Date: 11/07/2025

2027.00 Moss Lane East, Manchester

**Design Co-ordination Amendments**  
**Listed Building**

North Elevation as Proposed

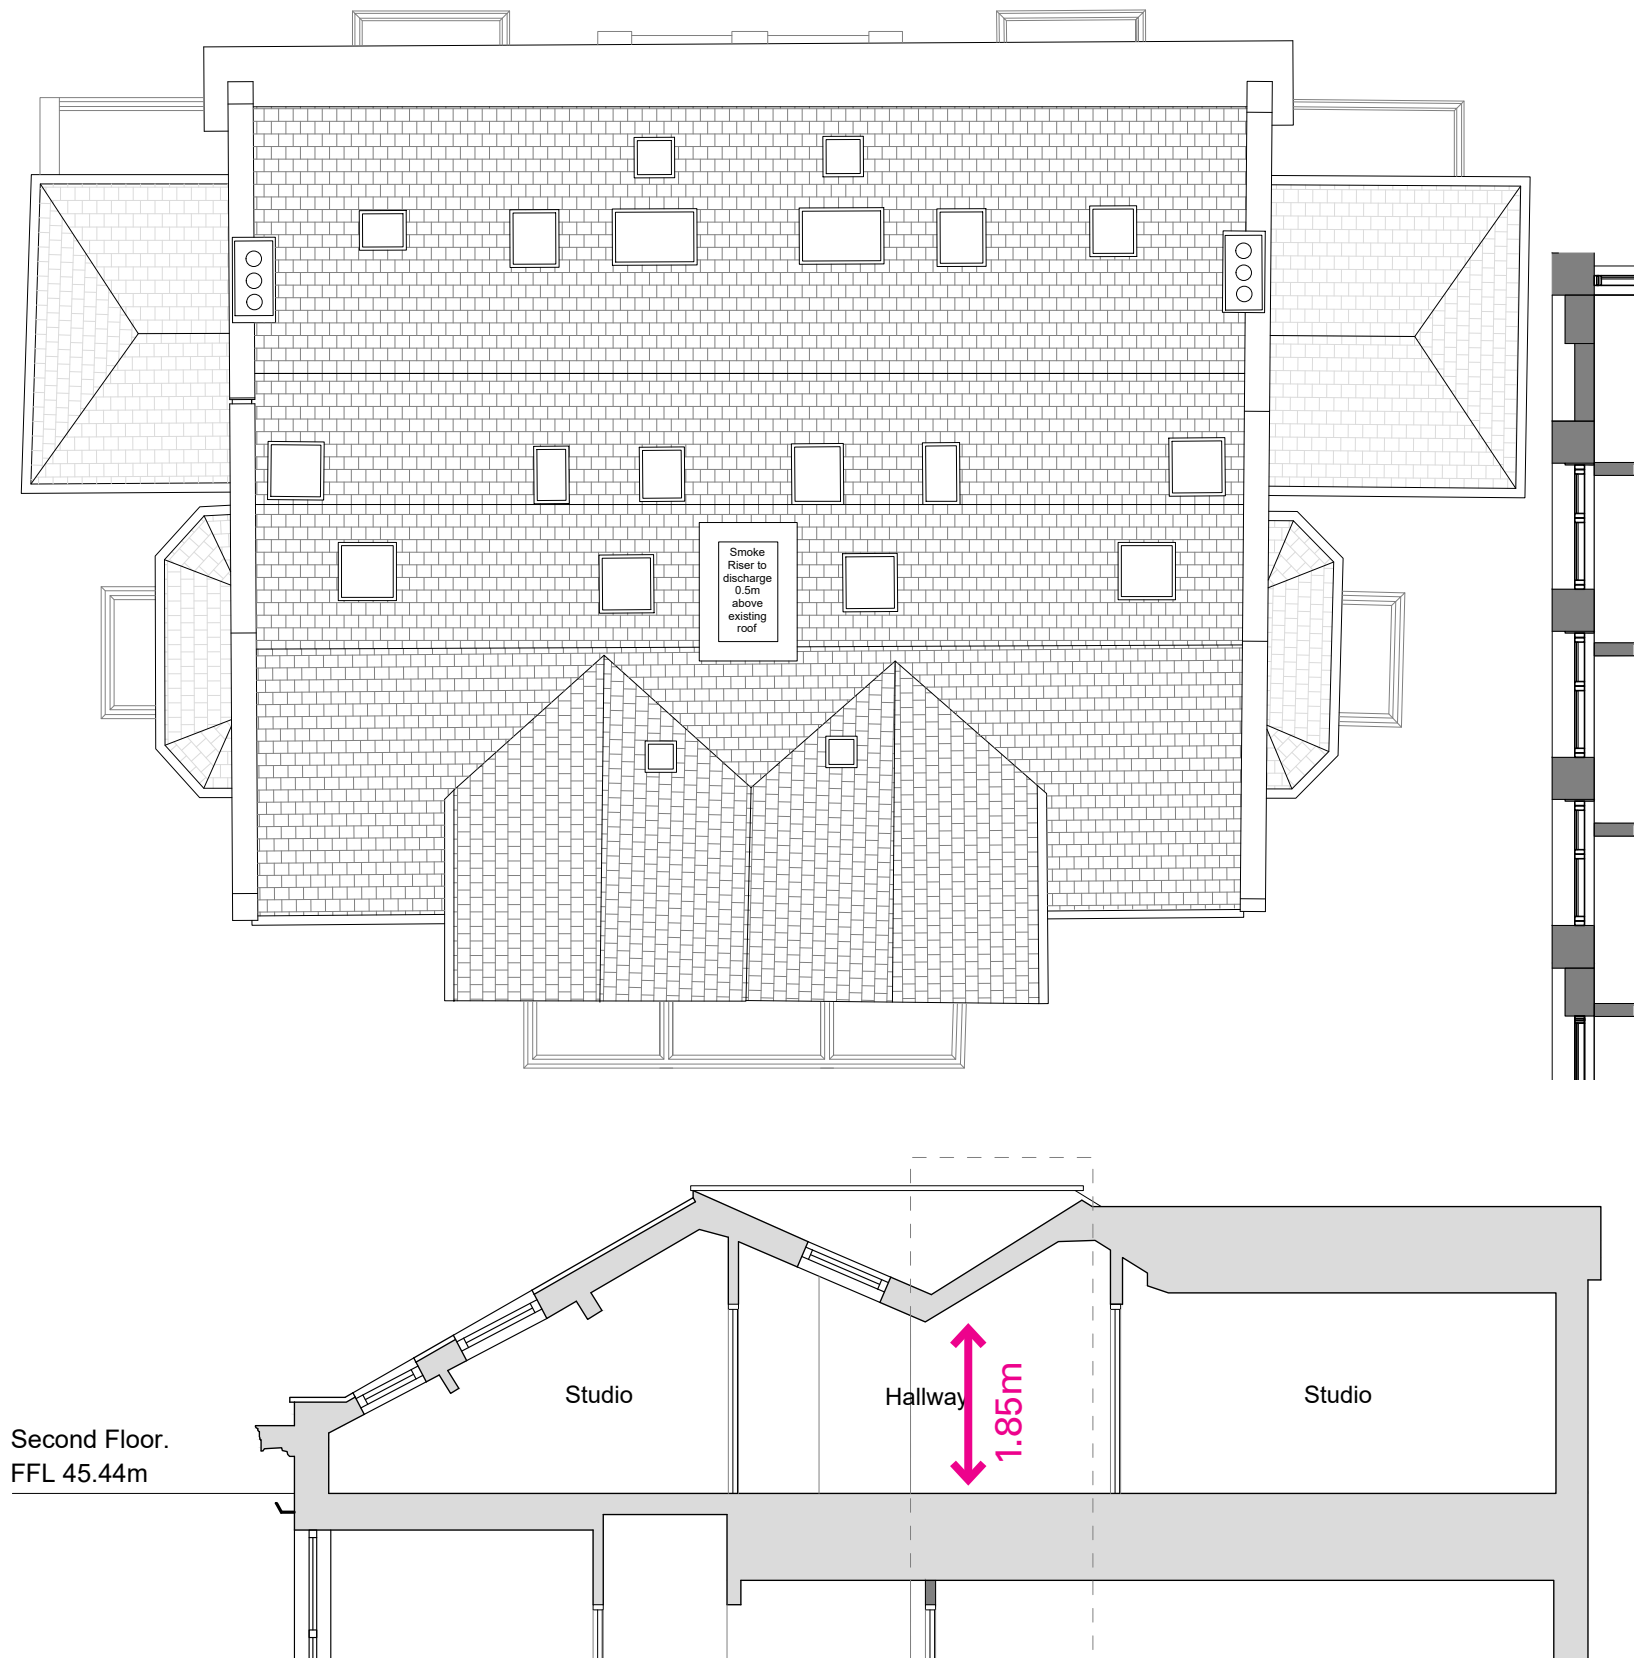
- The basis of the updated strategy is to retain as much of the existing window element as possible and carry out repairs necessary to preserve their original character. The type of repairs varies depending on the existing condition of each individual window.
- Where the existing condition is beyond repair, a full replacement of the window on 'like-for-like' basis is proposed.
- Keeping in with the original consented proposals, existing uPVC windows are proposed to be replaced with traditional timber sash&case windows, and windows are reinstated where currently bricked-up.
- Details of the proposed revised strategy are provided in a document prepared by the project's conservation architects Buttress Fuller. This document, along with a number of window detail drawings, accompany this submission.
- The elevation on this page shows an example of the proposed works to the windows.

1. Existing sliding sash window repaired and refurbished
2. Existing casement window repaired and refurbished
3. Altered sash window replaced with new hardwood sliding sash window to match existing proportions
4. Decayed sliding sash window replaced on a like for like basis
5. Casement window replaced with new hardwood framed vertical sliding sash window
6. Replacement hardwood framed multi-pane casement window
7. Reinstated hardwood framed multi-pane casement window
8. Existing door repaired and refurbished including overhead glazed panel

Roof Plan and Part Section as Proposed

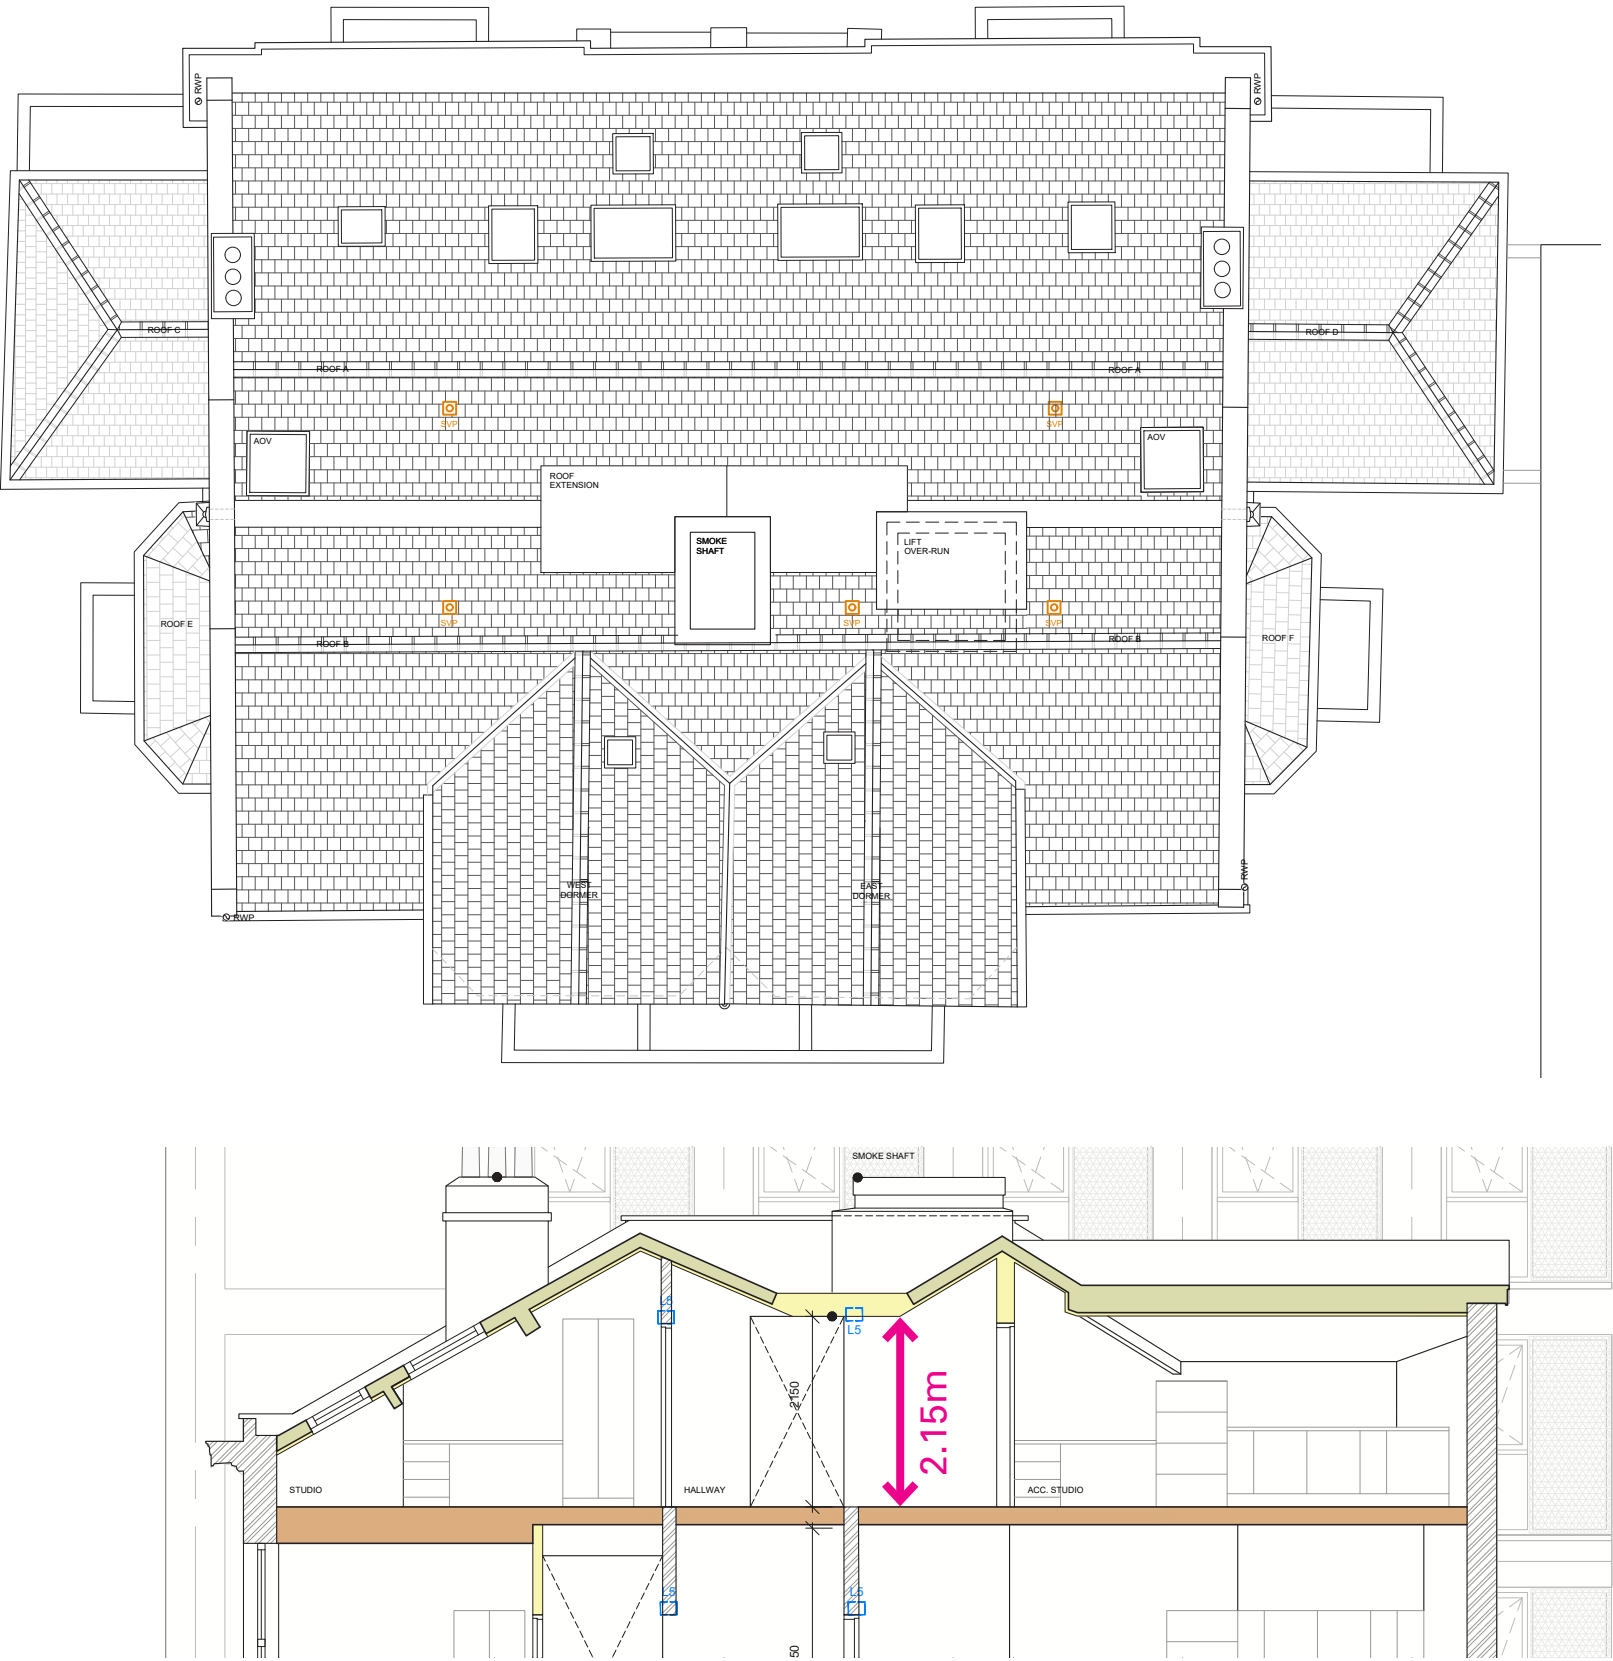
- The consented design provided for the required projection of the new smoke shaft above the adjacent roof level (0.5m) but no consideration was made for the required internal headroom in the newly formed hallway under the roof valley or for the new passenger lift shaft over-run at the roof level.
- Specifically, the existing roof structure would only provide a height of 1.85m under the roof valley which is insufficient and does not achieve the minimum headroom in communal corridors required by Building Regulations.
- The adjacent drawings show the proposed roof plan layout and a cross section through the building, as consented.

- A couple of minor modifications to the existing roof structure are therefore proposed to accommodate an adequate headroom in the communal hallway and to accommodate the new lift shaft over-run projection.
- Both of these modifications are limited to the roof valley area and are not visible from the street. The only visible new alteration to the existing roof is the smoke shaft - as per the consented design.
- The drawings on this page show the updated proposal for the roof plan layout and for the cross section, with the adjusted roof structure above the top floor level.

North &amp; West Elevation as Proposed

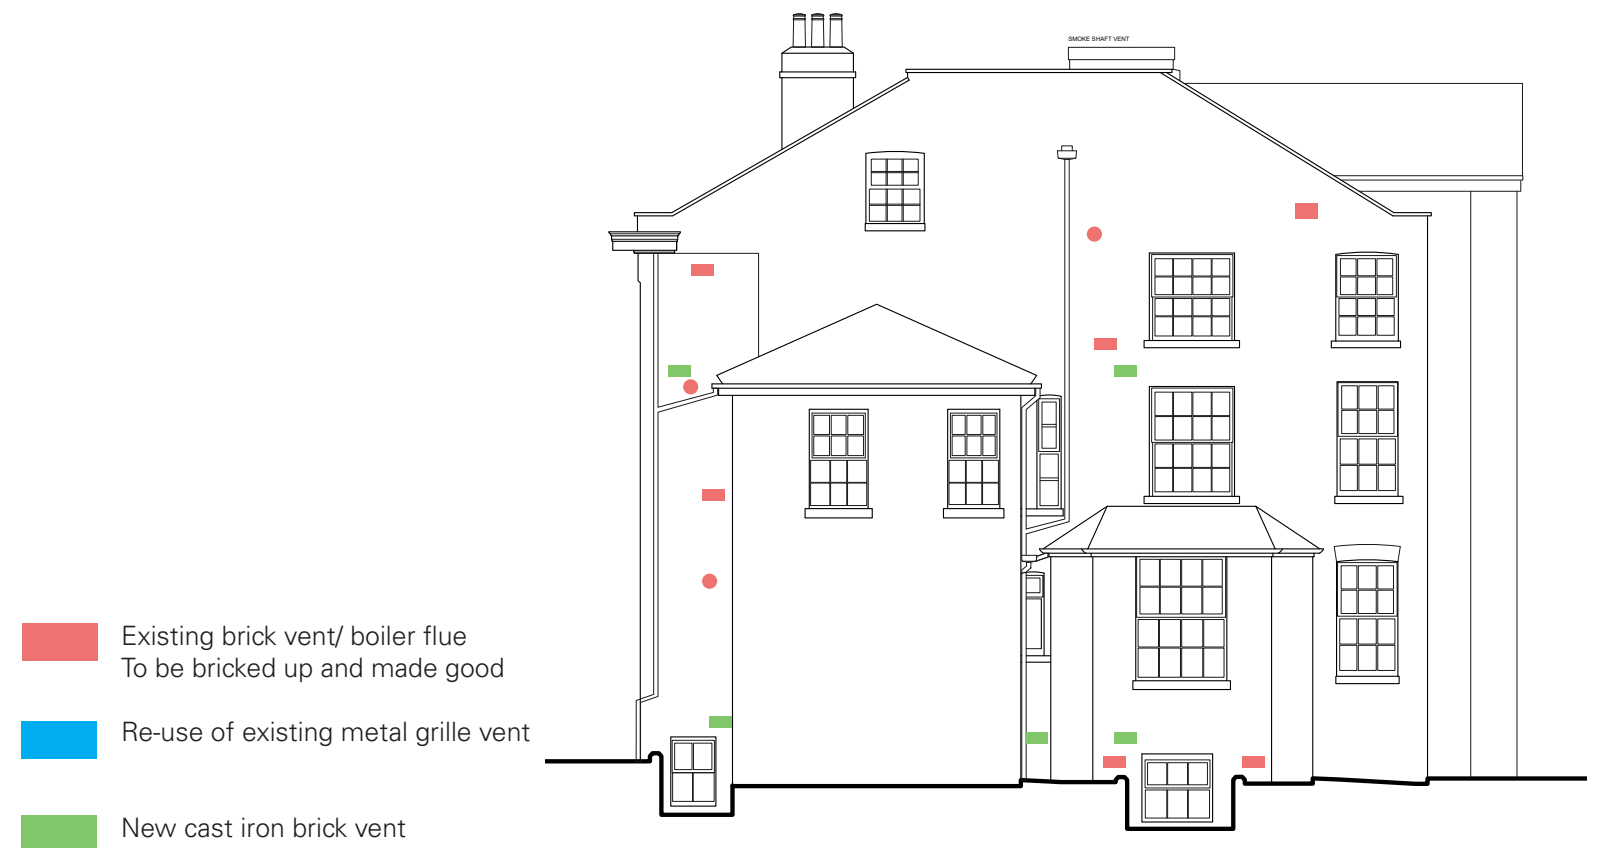
- The proposed location and detail of the vents has been carefully considered in where the terminals are focused to the rear and side elevations (away from the principal elevation), are kept to inconspicuous areas where possible, and are consistent in their setting out as far as reasonably practicable.

- It is proposed that the new ventilation terminals are to be in cast iron - a traditional and sympathetic option for the existing variegated red brick elevations. An example of this is shown on the next page.

- The elevation drawings shown on this page indicate the proposed location of the new cast iron vents to the West gable elevation, and re-use of existing metal vents on the North principal elevation.

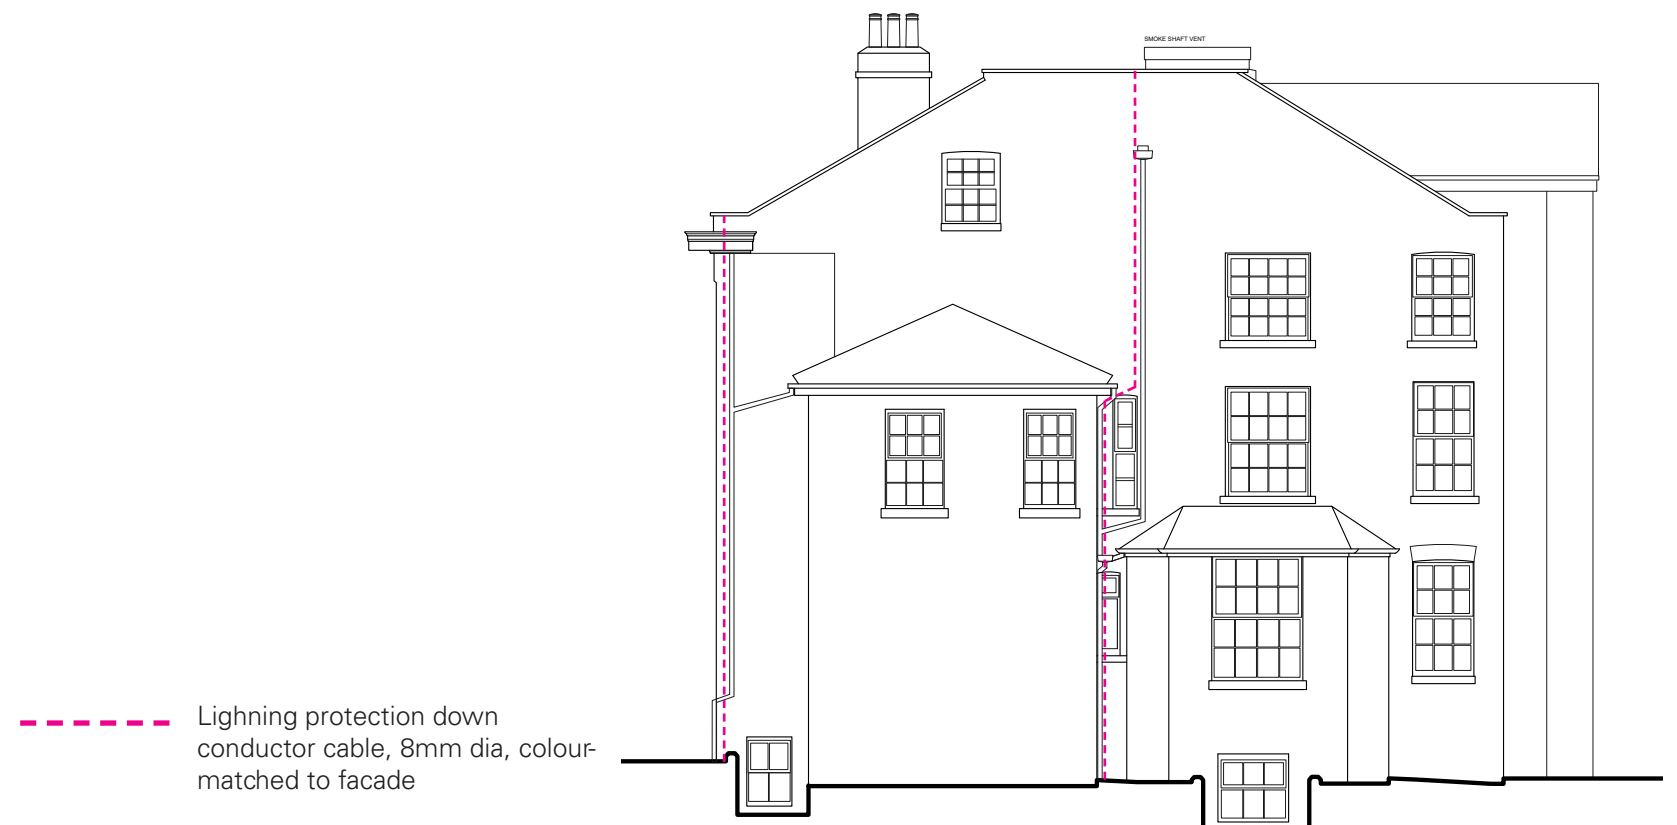
- As the listed building is connected to the new building, both structurally and functionally, this increases their shared infrastructure responsibilities, including fire and electrical safety systems. From M&E services design point of view, to ensure that the full development complies with relevant technical standards and legal obligations with respect to construction, fire and electrical safety systems, a specialist risk assessment has been carried out to determine requirements for lightning protection.

- Lightning protection is a legal requirement for new structures in the UK, including student housing buildings. The risk assessment concludes that lightning protection should be installed to the existing portion of the full development, i.e. to the listed building. This aims to ensure safety of the occupants and protection to the existing structure itself as well as the new electrical installations inside the building, from potential damage resulting from a lightning strike.

Lightning Layout as Proposed (Facades)

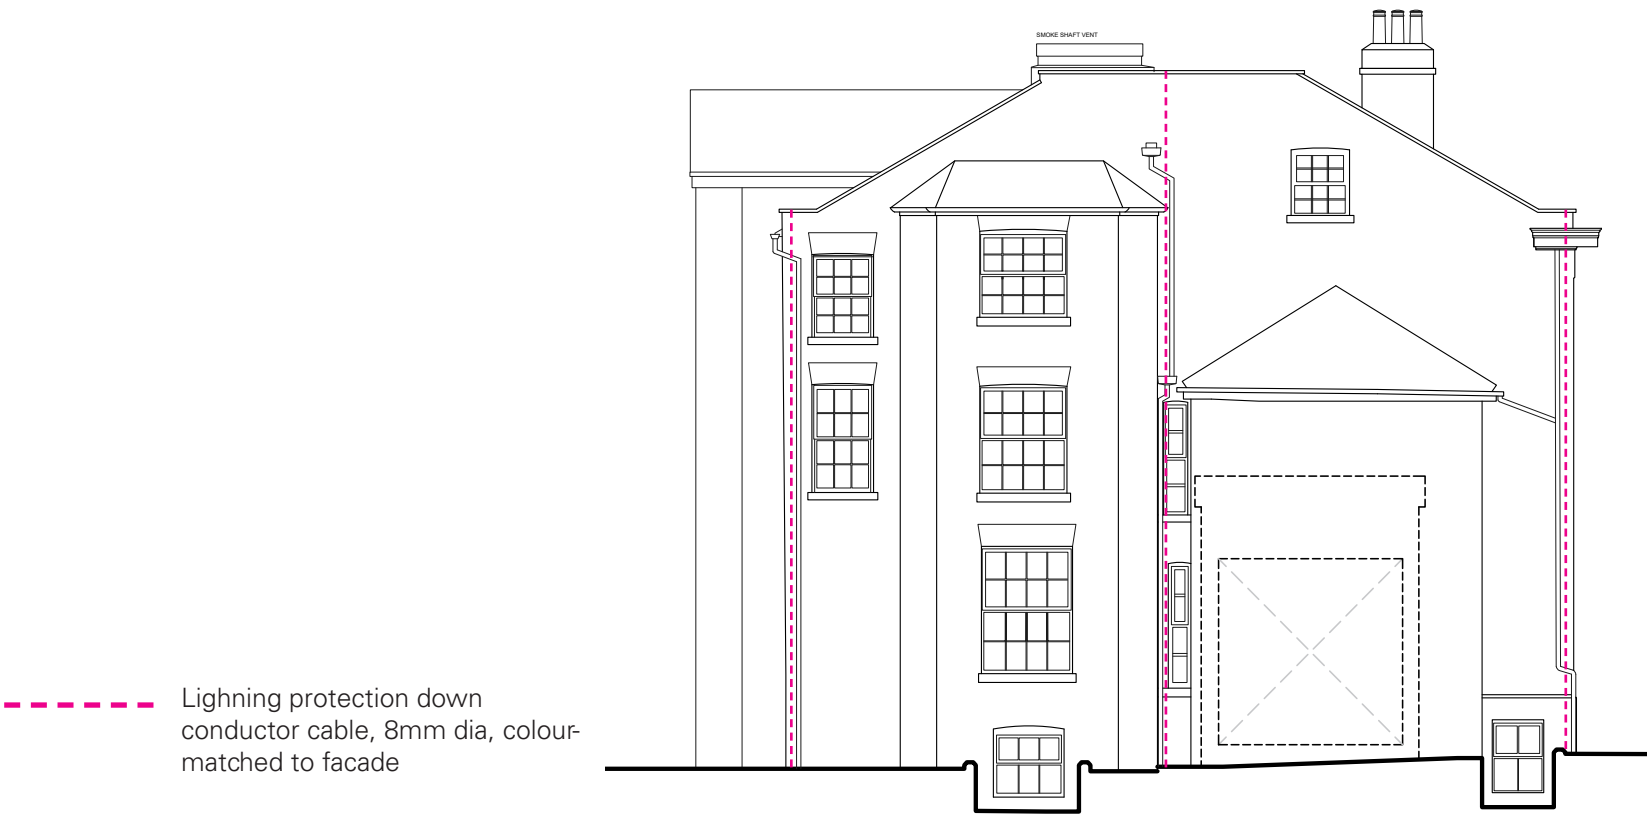
- Continuing from roof level down the facades, a series of down conductors are proposed around the building exterior. These are in form of circular cables (8mm in diameter) colour matched with the facade, and are positioned in recesses, corners, or behind rain water pipes, to reduce their visibility as far as reasonably practicable. The elevations on this and the previous page show the proposed locations of the down conductors for further reference. The principal (north) elevation is free from any lightning protection installations.
- Full details of the proposals as well as the risk assessment can be found in the aforementioned Lightning Protection Report, supplied with this document.
